25th August, 1996

BULLETIN #137

SYNCHRO-PULSE CDT CP38**PCB CP38-11****DISPLAY RESETTING FAULT**

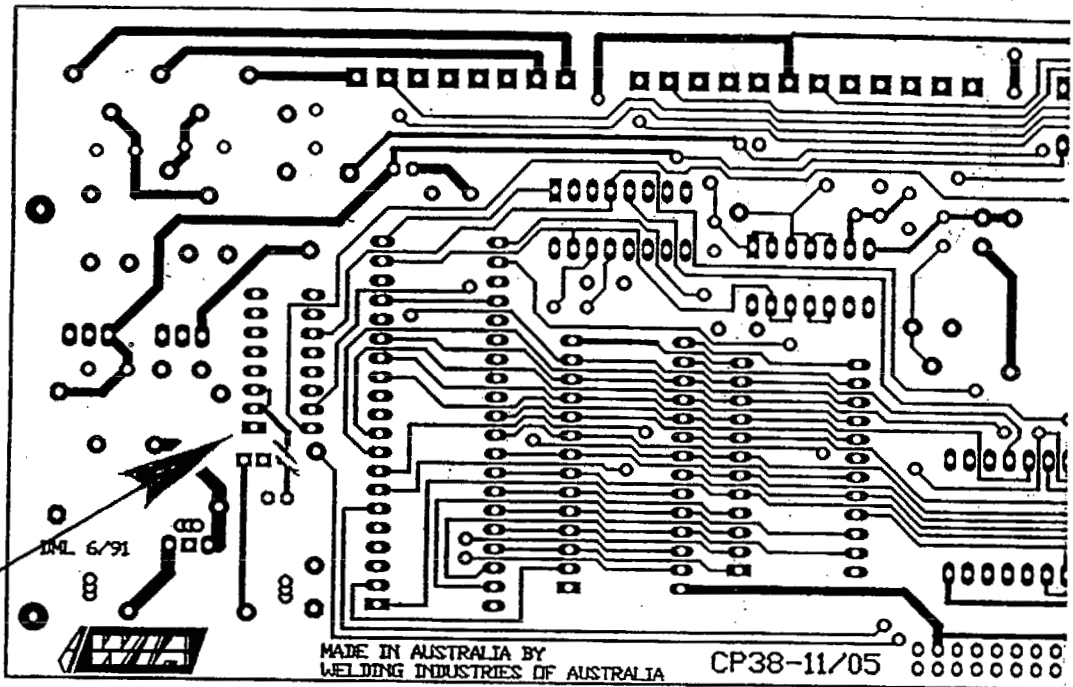
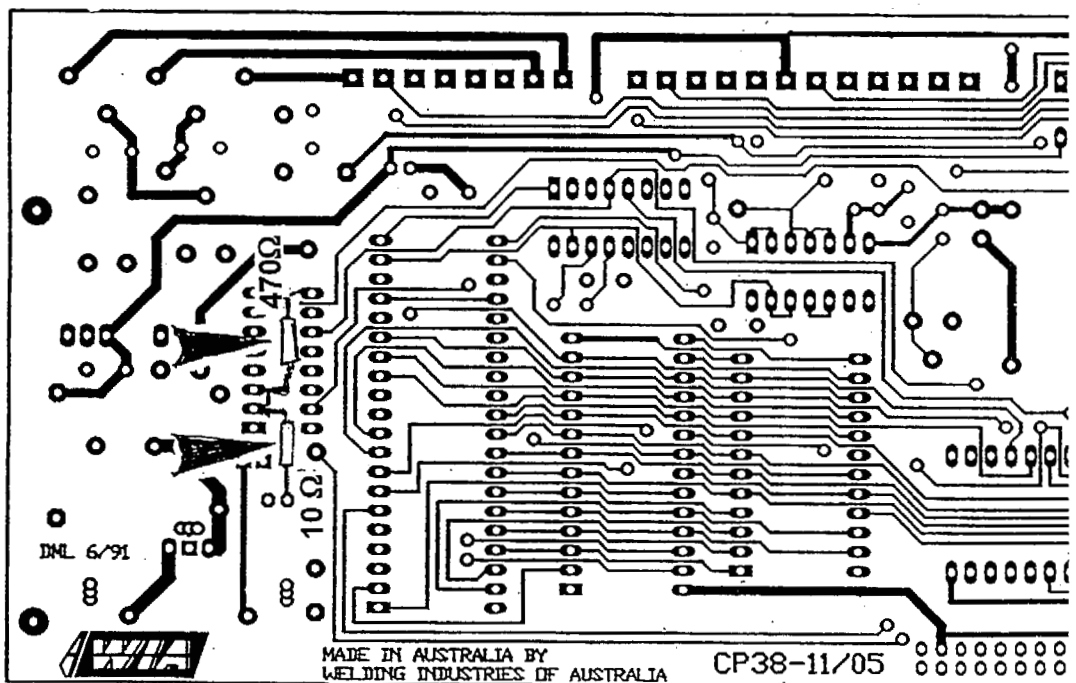
Cut track (on solder side) from pin 2 of U11 to C16

Add 470 ohm resistor from pin 3 of U11 to pin 9 of U11
Add 10 ohm resistor from pin 2 of U11 to C16

- On the underside of the CP38-11 pcb, cut the track from pin 2 of U11 to C16;
- Solder a 10 ohm resistor from pin 2 of U11 to C16 (in place of the track);
- Solder a 470 ohm resistor from pin 3 of U11 to pin 9 of U11.
